STAFF RECOMMENDATION
2111 Natchez Trace
April 22, 2020

Application: New Construction—Addition
District: Hillsboro-West End Neighborhood Conservation Zoning Overlay
Council District: 18
Base Zoning: RS7.5
Map and Parcel Number: 10411021600
Applicant: Tyler LeMarinel, Allard Ward Architects
Project Lead: Melissa Sajid, melissa.sajid@nashville.gov

Description of Project: Application is to construct a rear addition that extends wider on the left side. The application includes demolition of an enclosed rear porch. **Recommendation Summary:** Staff recommends approval with the following conditions: **1.** Staff approve the final details, dimensions and materials of windows, doors, and roof color prior to purchase and installation; and, **2.** The HVAC and utility meter shall be located behind the house or on either side, beyond the midpoint of the house. Alternative mechanical and utility locations must be approved prior to an administrative sign-off on building permit(s). With these conditions, staff finds that the project meets Section II.B of the *Hillsboro-West End Neighborhood Conservation District: Handbook and Design Guidelines*.	**Attachments** **A:** Photographs **B:** Site Pl

Figure 2. 1957 Sanborn map.

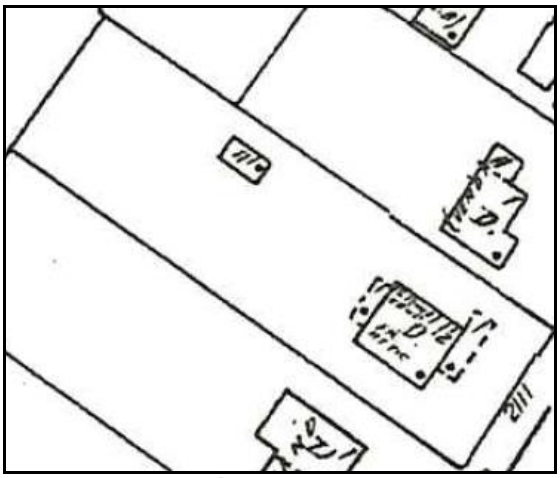
Partial Demolition: The applicant proposes to demolish an existing enclosed rear porch. The 1957 Sanborn map shows a covered rear porch in this location that has since been enclosed (Figures 2 and 3). Given the porch's location at the rear of the house and alterations since 1957, staff finds that the porch is not a character defining feature of the historic house and demolition can be appropriate. No other changes to the historic house are proposed with this application.

Staff finds that the proposed partial demolition meets Section III.B.2 for appropriate demolition and does not meet Section III.B.1 for inappropriate demolition.

1 Site Layout Plan

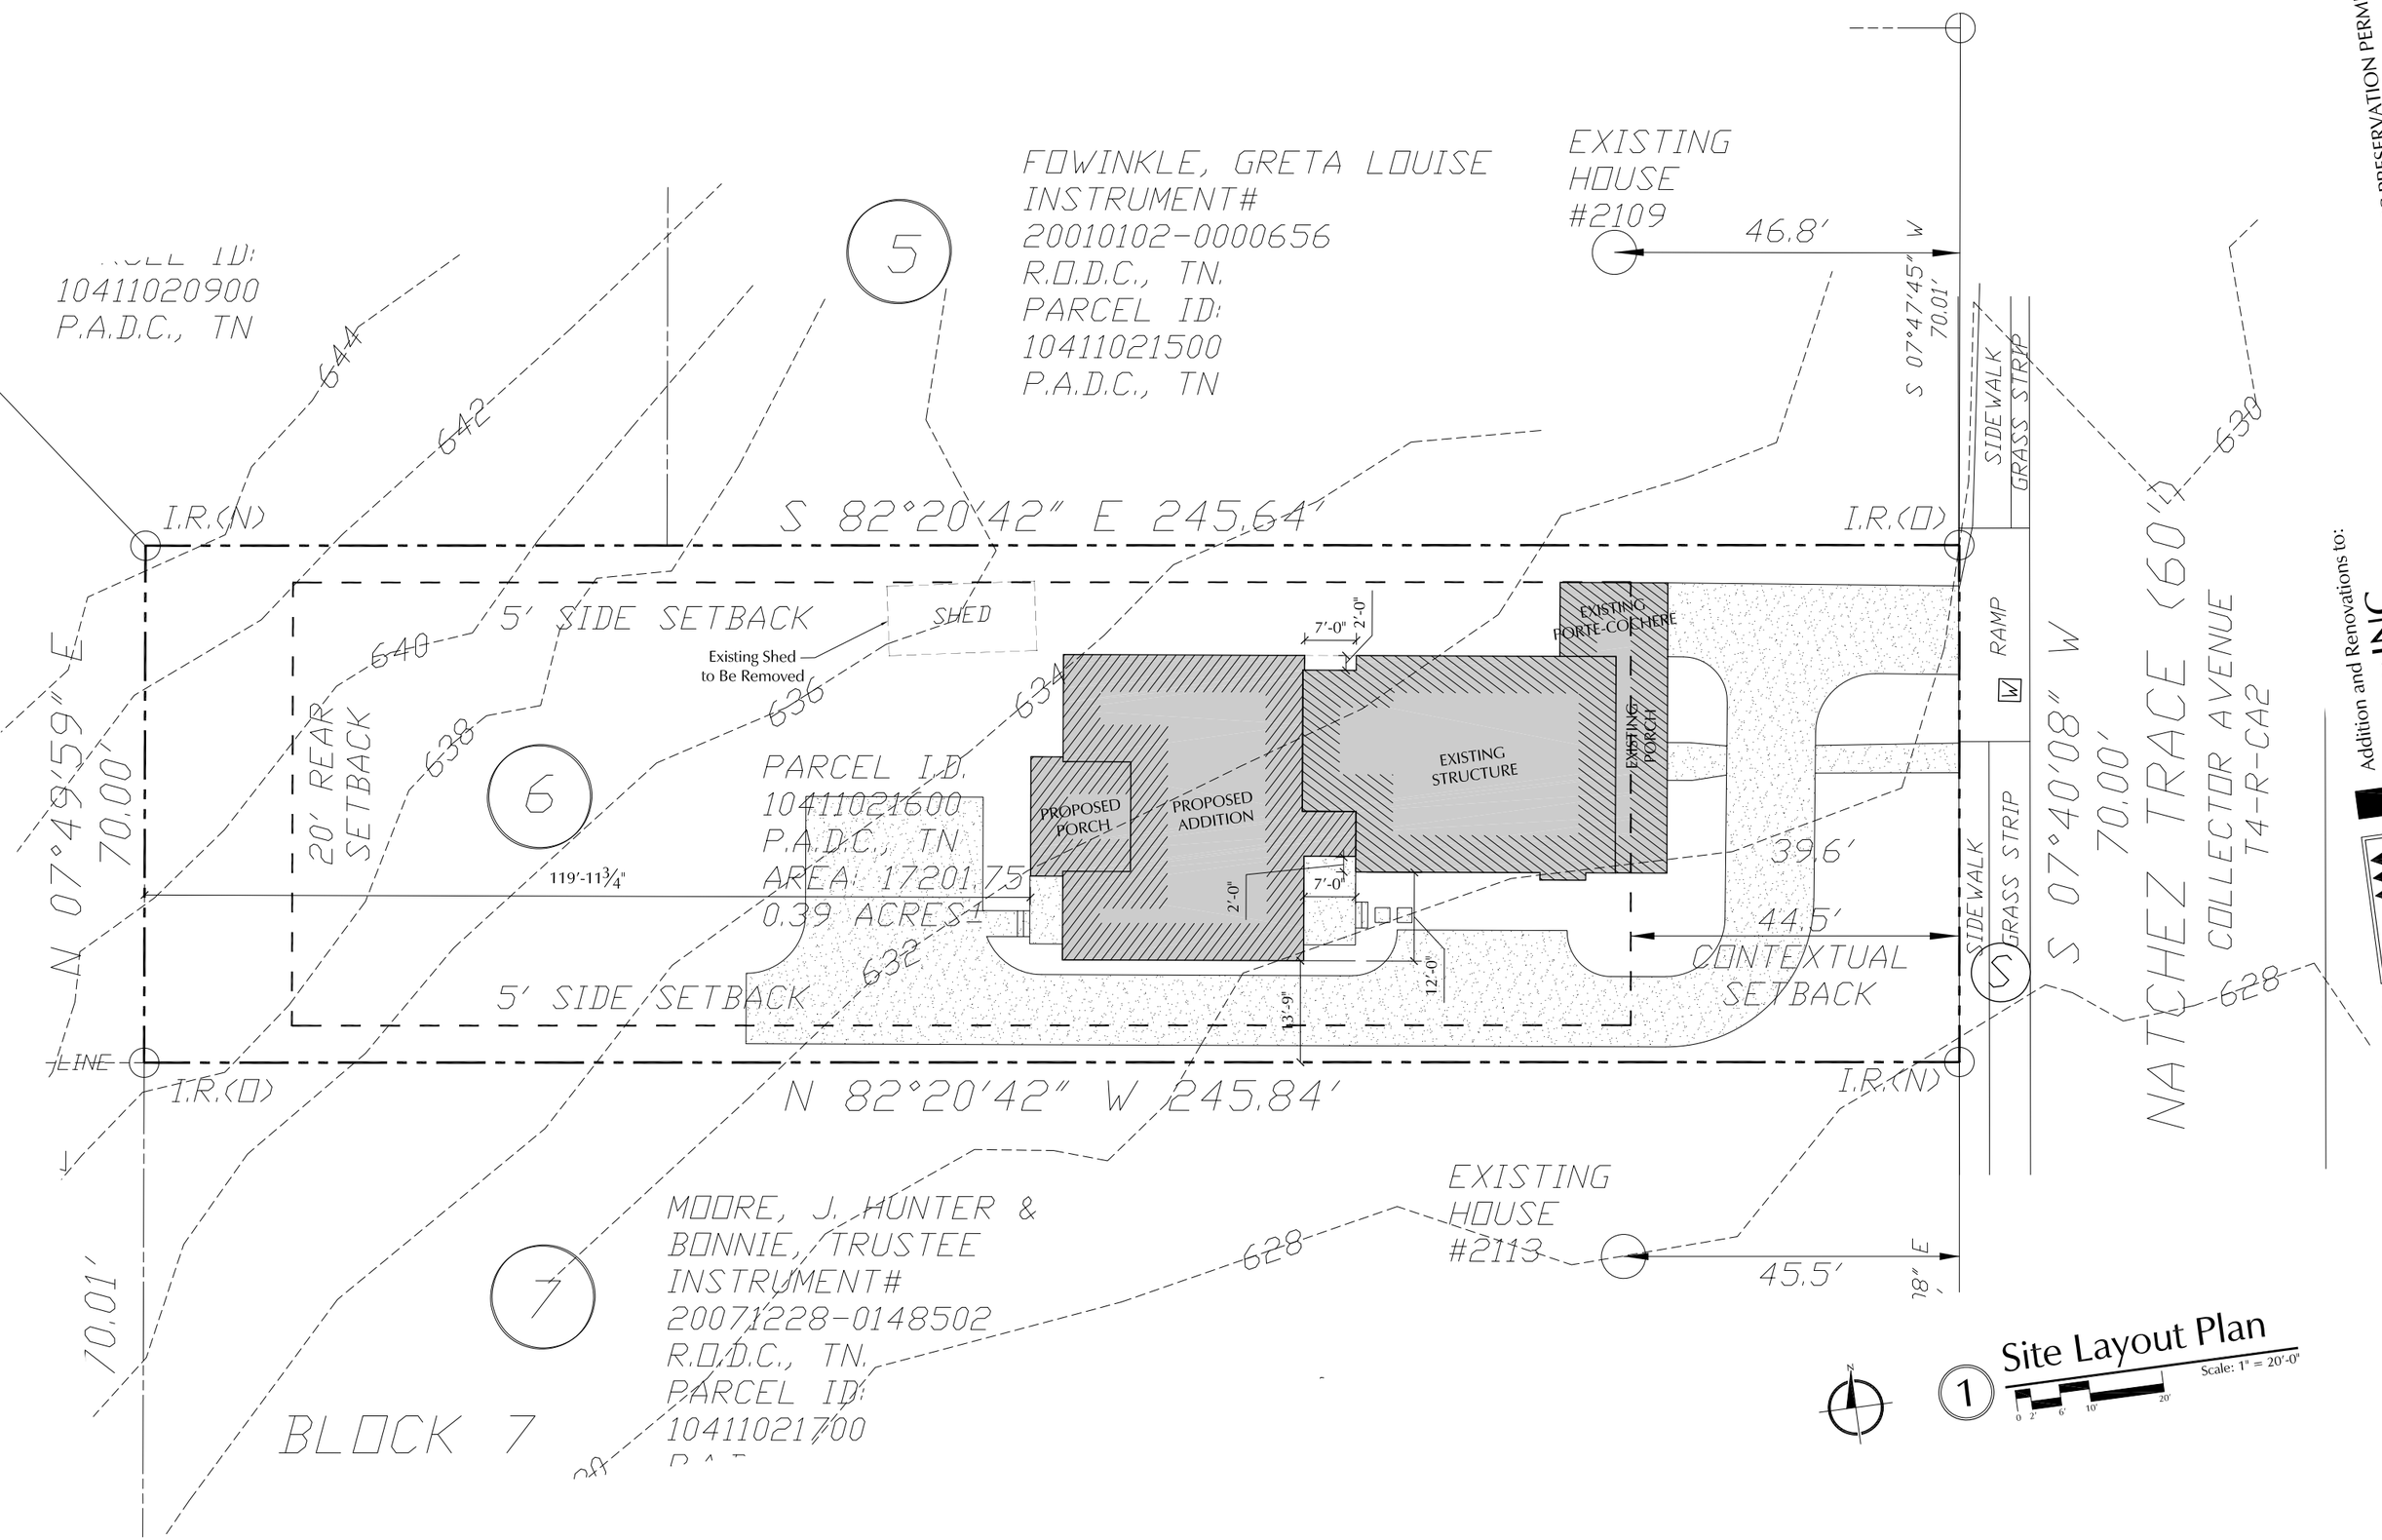
Setback & Rhythm of Spacing: The addition meets all base zoning setbacks and will be thirteen feet, nine inches (13'-9") from the left-side property line, fifteen feet (15') from

the right-side property line, and one hundred twenty feet (120') from the rear property line.

The project meets Section II.B.1.c.

1 Roof Layout Plan

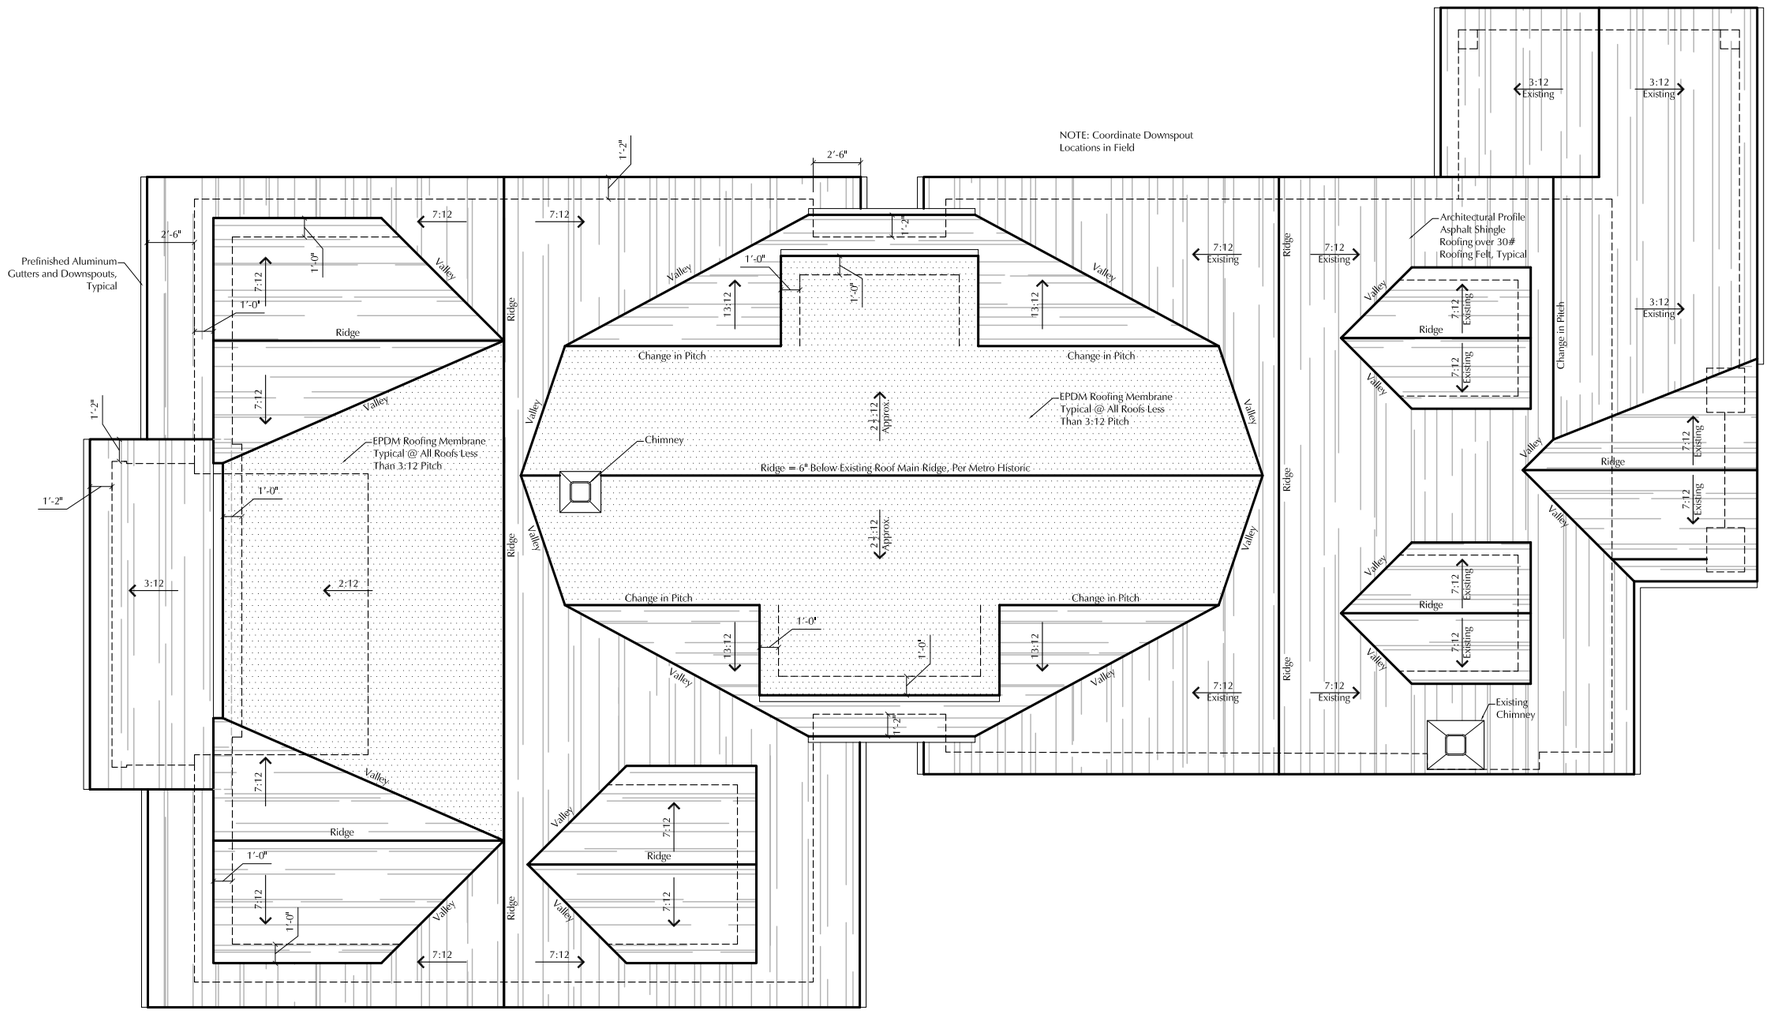
Roof form: The addition has a cross-gabled form that incorporates dormers on the sides, rear, and front façade of the wider portion. The primary roof pitch of the addition and dormers is 7/12 to match that of the historic house. The part of the addition that ties into the existing roof and connects to the side-gabled piece of the addition is a lower slope membrane roof with a pitch of 2.5/12. While the design guidelines indicate that "historic roofs are generally between 6/12 and 12/12," staff finds that the proposed lower slope roof could be appropriate as proposed with this project since it will be minimally visible and helps to keep the overall height of the addition lower than the historic house. All dormers meet the design guidelines for size and location in relation to lower-level walls.

The project meets Section II.B.1.e.

Drawings:
Elevations

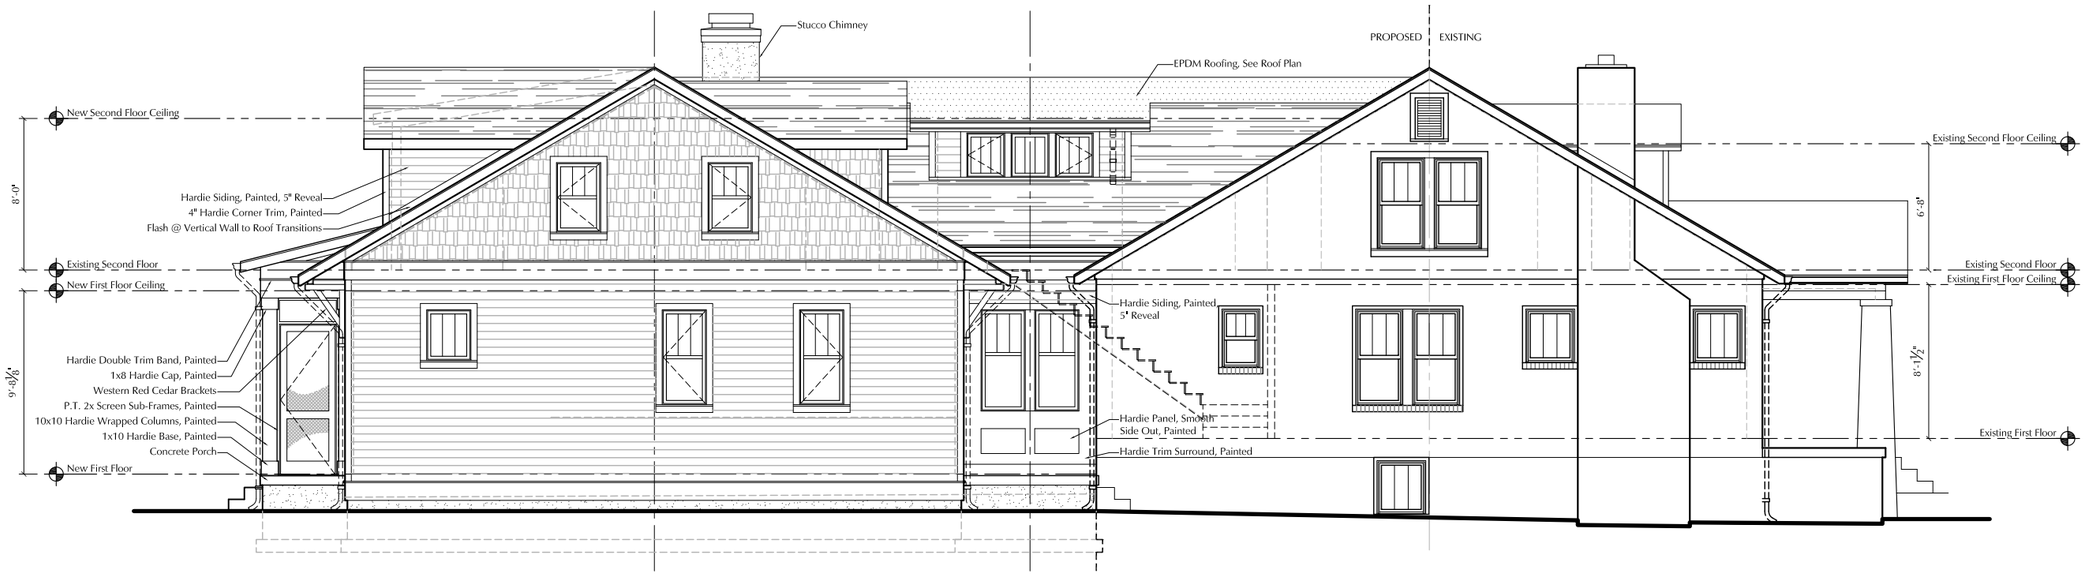
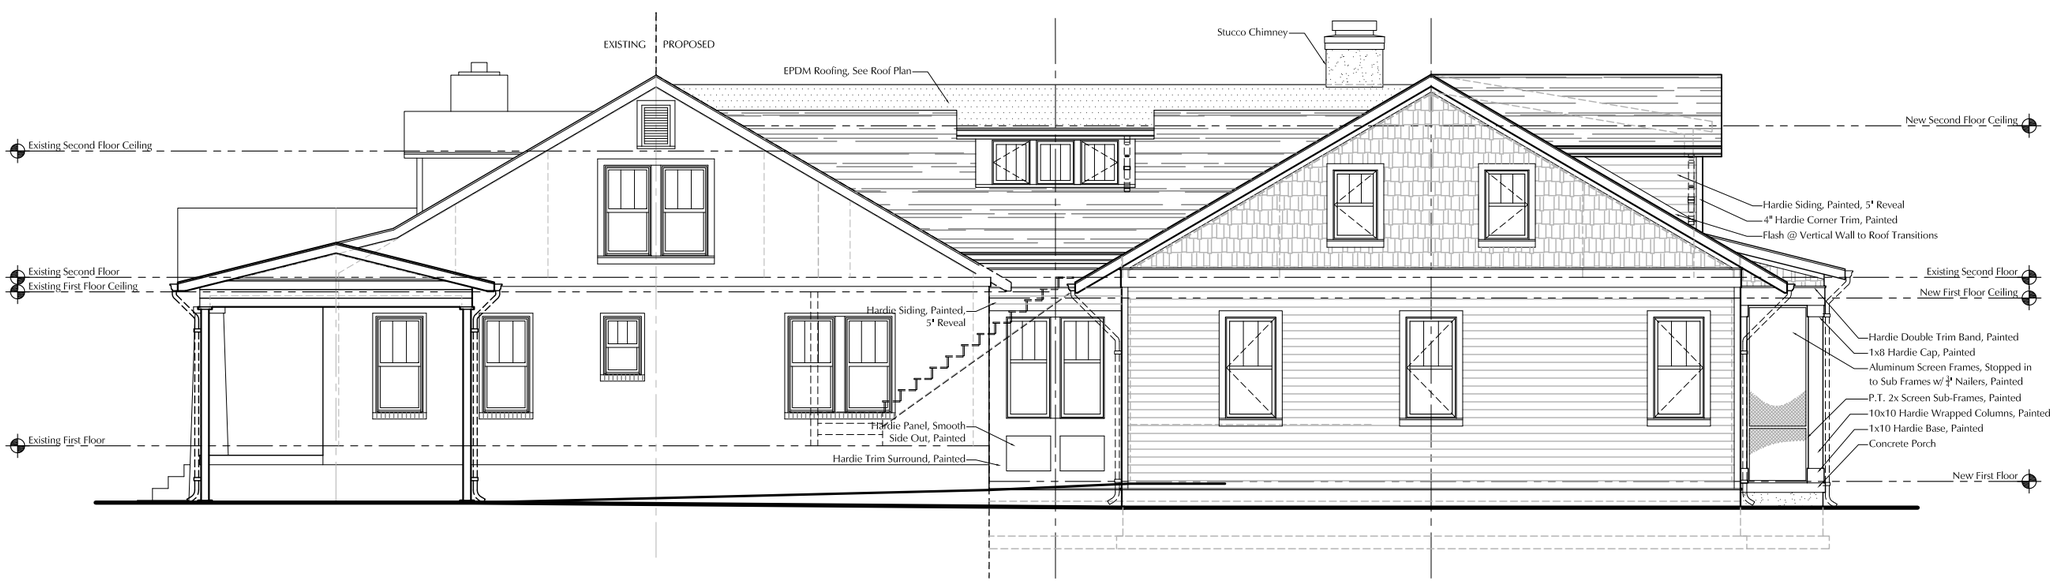
Design, Location & Removability: The bulk of the addition is located at the rear and is inset two feet (2') from the rear corners of the historic house, which meets the design guidelines, before going back seven feet (7') to create an alcove. On the right-side, the addition comes back out to be flush with the side wall of the historic house whereas, on the left-side, the addition extends eleven feet (11') wider than the side wall of the historic house.

The wider rear addition meets the design guidelines for when an addition may be wider, does not wrap the rear corner, and meets the design guidelines for an appropriate structural alcove. The wider part of the addition occurs approximately forty-six feet (46') behind the front wall of the historic house and has a side-gabled roof form, which helps deemphasize the massing. In addition, the ridge and eave heights are similar to those of the historic house.

The addition will be clad in Hardie siding with a cedar shake siding accent and will have a parged concrete foundation. With the condition that the final details of the materials for the windows, doors, and roof color be approved prior to purchase and installation, staff finds that the project meets Section II.B.1.d

Proportion and Rhythm of Openings**:** The windows on the proposed addition are all generally twice as tall as they are wide, thereby meeting the historic proportions of openings. There are no large expanses of wall space without a window or door opening.

1. Staff approve the final details, dimensions and materials of windows, doors, and roof
2. The HVAC and utility meter shall be located behind the house or on either side, beyond the midpoint of the house. Alternative mechanical and utility locations must be approved prior to an administrative sign-off on building permit(s).
